TO: Louise Olivarez, Senior Planner
FROM: Charles Marker, Deputy Director of Public Works *C M M*
DATE: May 17, 1982
SUBJ: Sketch Plat of Walnut Valley Addition & Whistling
Walk Estates 4th Addition

Re: S/D 83-114 - Preliminary plat of Walnut Creek Addition

Re: S/D 83-114 - Final plat of Walnut Creek Addition

*Lot 4, Block 2, WALNUT CREEK ADDITION,
Wichita, Sedgewick County, Kansas*

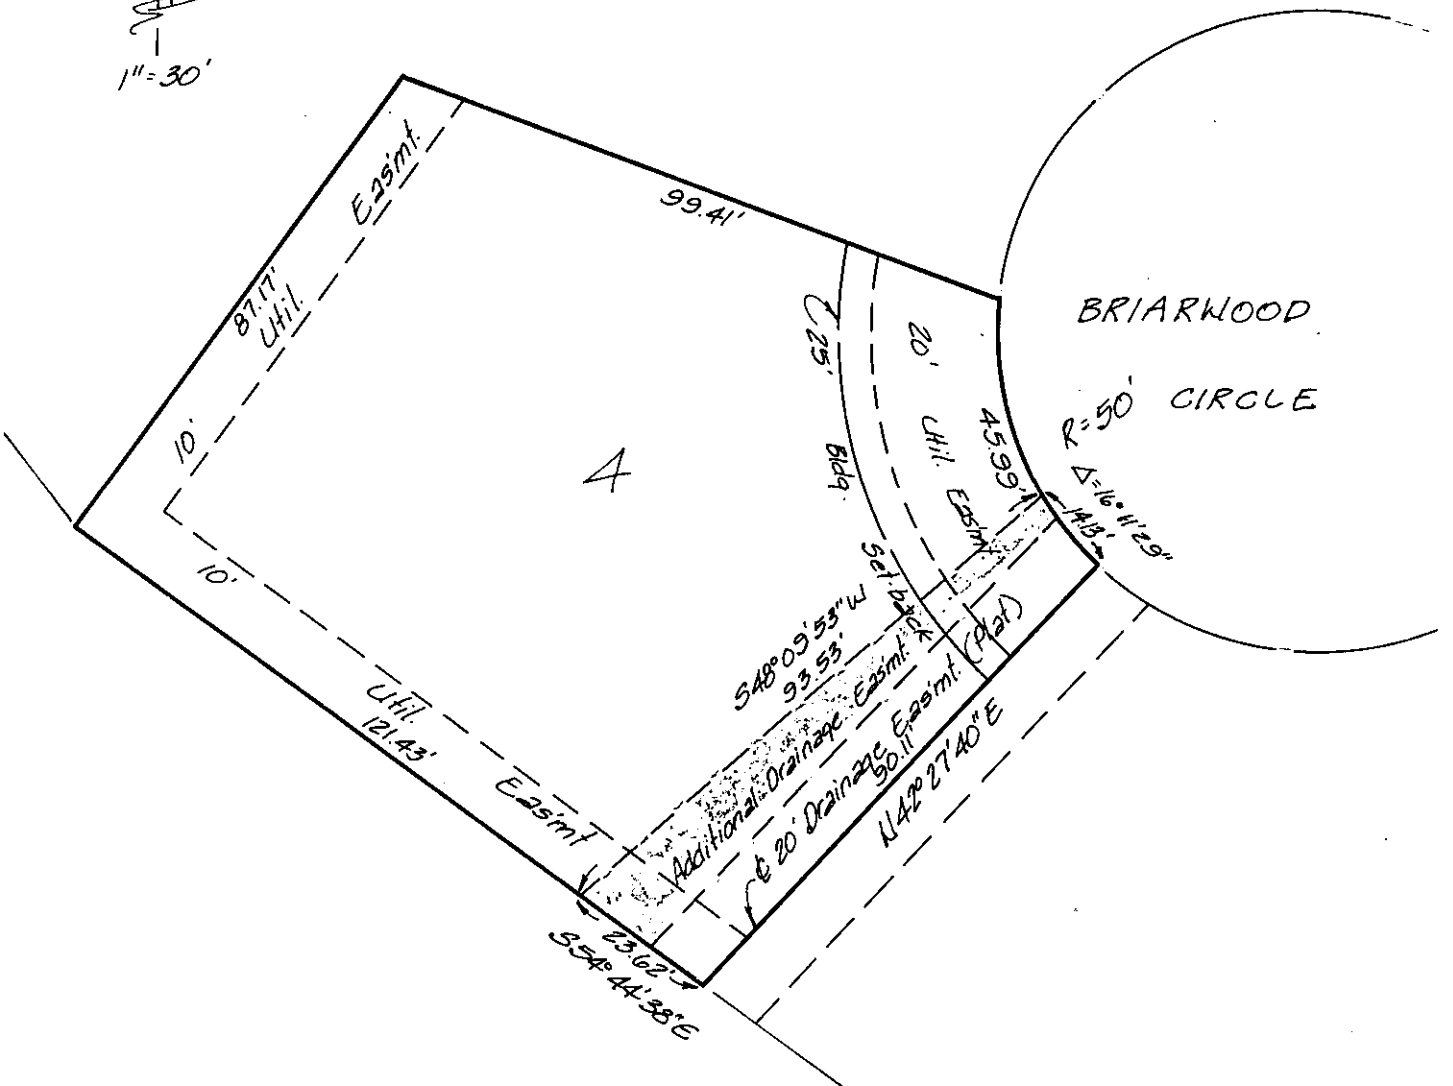
In regards to the storm sewer which was constructed out of the plat-
ted drainage easement on Lot 4, Block 2, Walnut Creek Addition, I have
been in contact with the home builder and the owners of the lot.

I have obtained an additional drainage easement which provided three
foot of clearance from the outer edge of the R.C.P. The home site has
been re-adjusted on the Lot to allow for the new additional drainage ease-
ment.

I have recorded the signed drainage easement and attached herein a
copy for your files as well as a Lot drawing which reflects the additional
easement.
